**CITY OF SAINT PAUL
HERITAGE PRESERVATION COMMISSION STAFF REPORT**

FILE NAME: 397 Ashland Avenue
APPLICANT: Nick Carmichael
OWNER: Nick Carmichael
DATE OF APPLICATION: January 11, 2016
DATE OF PUBLIC HEARING: January 28, 2016
HPC SITE/DISTRICT: Historic Hill Heritage Preservation District
CATEGORY: Contributing **WARD:** 1 **DISTRICT COUNCIL:** 8
INVENTORY NUMBER: RA-SPC-0134
CLASSIFICATION: Building Permit
STAFF INVESTIGATION AND REPORT: Christine Boulware
DATE OF REPORT: January 25, 2016

1 Site Plan
1" = 12'-0"

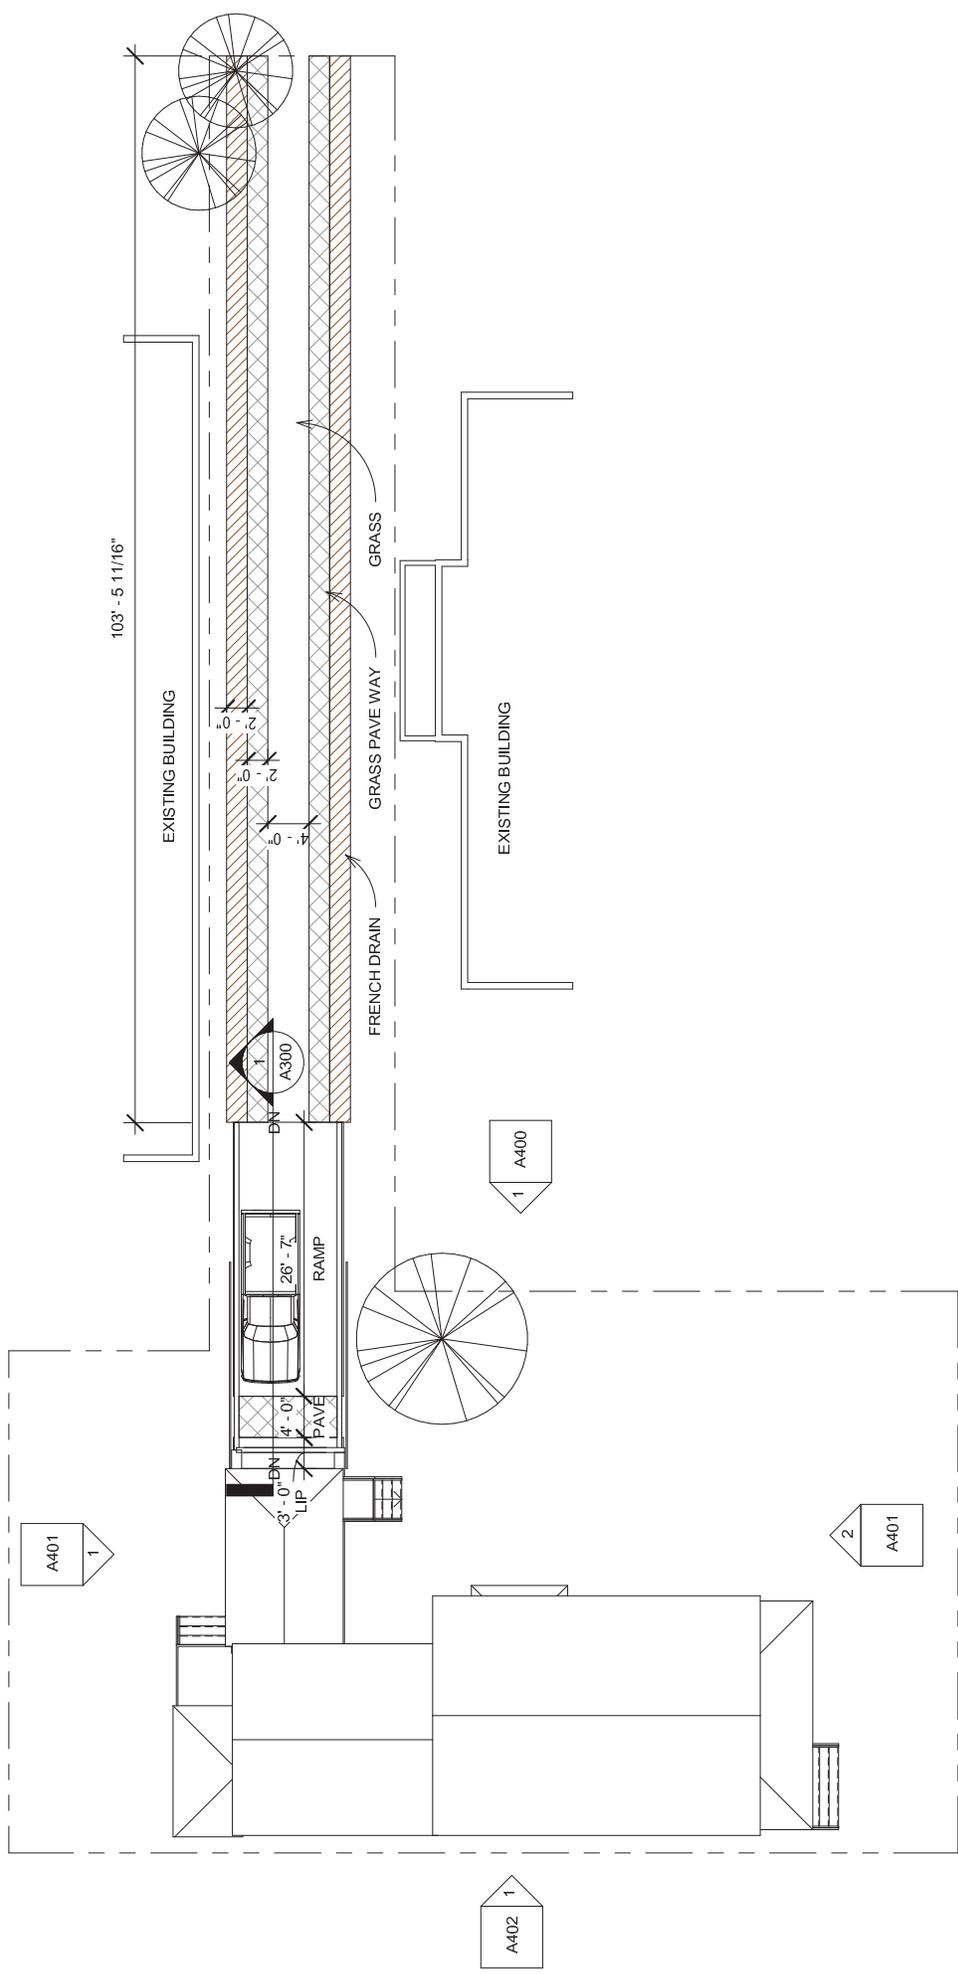
9. **Site: Landscaping** Leg. Code §74.65(f)(2)b. While there are no boulevard trees in the location where the curb cut and driveway apron are proposed, there are a cluster of trees on the property, next to the sidewalk, that will most likely be removed. The paving material is a Turfstone ribbon driveway until the grade slopes to the garage entrance. The paver design allows for vegetation to grow through it which will lessen the visual and physical disturbance of the driveway strip between the apartment building and house on the corner.

13. **Public Infrastructure** Leg. Code §74.65(g)(2) The new, poured concrete sidewalk at the driveway area will need to match the existing sidewalk width along with color and scoring pattern.

4. The historic, cast iron fence at 385 Ashland Avenue shall be protected throughout the construction process.
5. The applicant shall obtain all necessary approvals from Public Works to install a driveway curb cut and apron. If granite or sandstone curb is present at the location, it shall be salvaged by the contractor and stored by Public Works for reuse in the heritage preservation districts and sites.

| Driveway Ramp Section | | | |

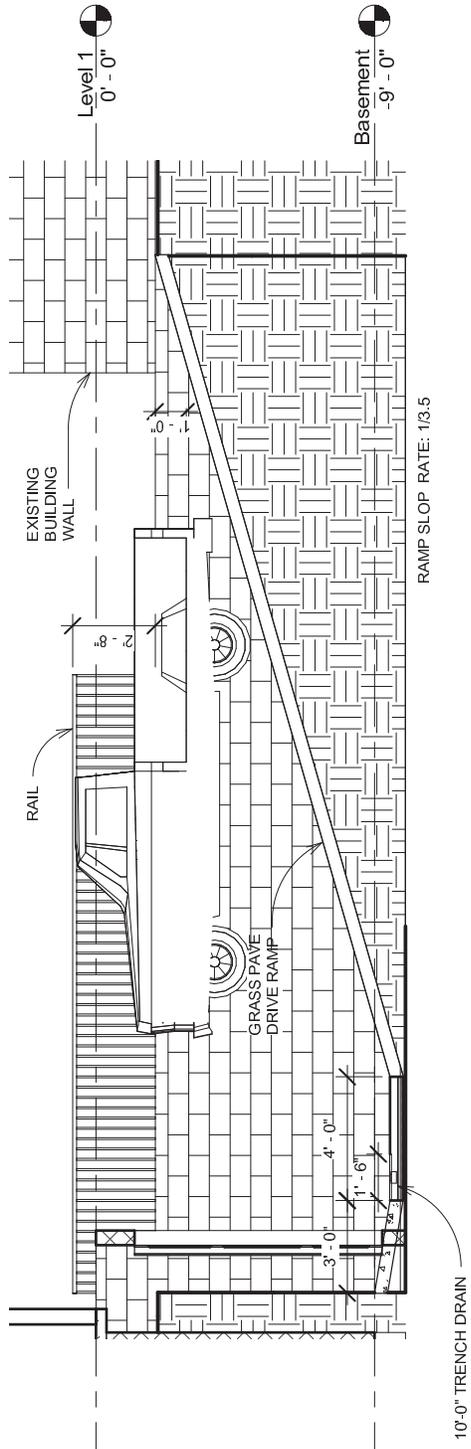
8. **Site: Landscaping** Leg. Code §74.65(f)(2)a. Details for the fence/railing proposed along the top of the retaining wall was not provided. Enclosures which allow visual penetration of semipublic spaces, such as wrought-iron fences, painted picket fences, low hedges or limestone retaining walls, are characteristic of most of the Historic Hill area and wood privacy fences and taller hedges are permitted in the rear yard. This approach to landscaping and fences is encouraged and final details will be required. The proposed retaining wall block has a beveled edge which does not relate to the foundation material or traditional stone walls in the historic district. The block should resemble the foundation in color and the block face should be flat with a rock- or split-faced texture. The cast-iron, ornamental fence at 385 Ashland, adjacent to the driveway, is a historic, character defining feature of 385 Ashland Avenue and precautions should be taken to avoid damage.

3. The new retaining walls shall be a limestone color to match the foundation, have a flat face with a rock- or split-faced texture. The wall shall have a cap. Final retaining wall materials and details shall be submitted to HPC staff for final review and approval.

| East Elevation | | | |

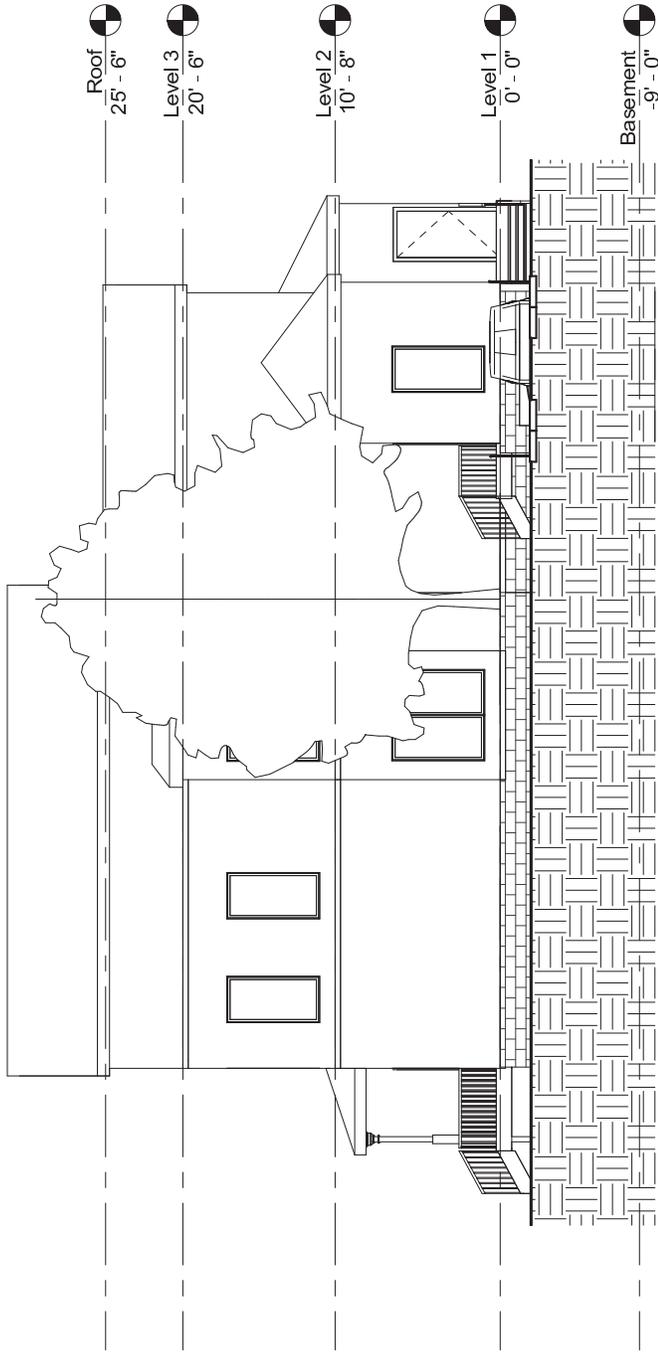
7. **Masonry and Foundations** Leg. Code §74.64(b)(2) &(3) The application does not address how the limestone foundation on the house will be repaired and/or repointed once the garage door opening is cut and framed. Replacement mortar should be softer than the masonry units and no harder than the historic mortar. The original color and texture of masonry surfaces should be retained and unpainted masonry surfaces should not be painted. A scope-of-work and mortar specifications will be required for final review and approval.

1. A masonry scope-of-work and mortar specifications shall be provided to HPC staff for final review and approval
2. A detailed plan for the proposed railing/fencing along the retaining walls shall be provided to HPC staff for final review and approval.
